Re: St. Paul's University Catholic Center
723 State Street, City of Madison
Our File No.: 071656

DATE: March 9, 2010

SUBJECT: St. Paul's University Catholic Center, 723 State Street

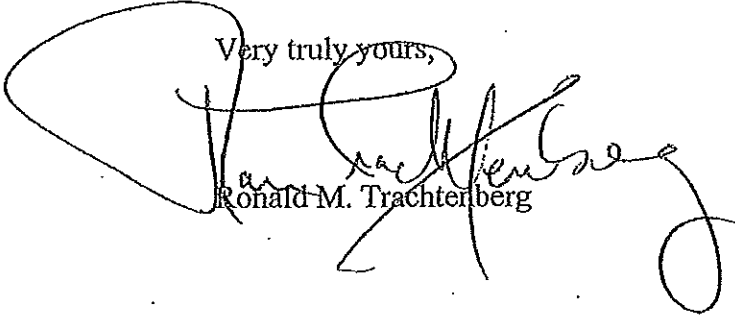
Planning staff have reviewed the most recent concept plans for the project (attached). While none of the elevations are dimensioned, it appears that the proposed building is similar (14 stories versus 15 stories) to the concept plans reviewed by staff in 2007.

In meetings with St. Paul's in 2007 and later in the aforementioned letter, staff expressed concerns about the scale and mass of the building as it related to other buildings in the vicinity and, in particular, the Pres House development which is immediately adjacent to the west. The University Presbyterian Church is a designated City of Madison Historic Landmark building. From the massing diagrams it appears that the building will be substantially out of scale with the Pres House development and other buildings on State Street. The Madison Zoning Code Section 28.04(3)(n) states that:

Because the concept plans received are not fully dimensioned it is difficult to say whether the Capitol View Preservation Limits will have an effect on this project.

In 2007 we encouraged the designers to consider making significant changes to reduce the scale and massing of the building, taking cues from the then recently approved Pres House expansion project. Since no contextual drawings have been presented which show the proposed project in relationship to other buildings within the area, it is difficult to fully evaluate the proposed relationship between the proposed project and nearby structures. However, it appears that our comments and concerns from 2007 would remain.
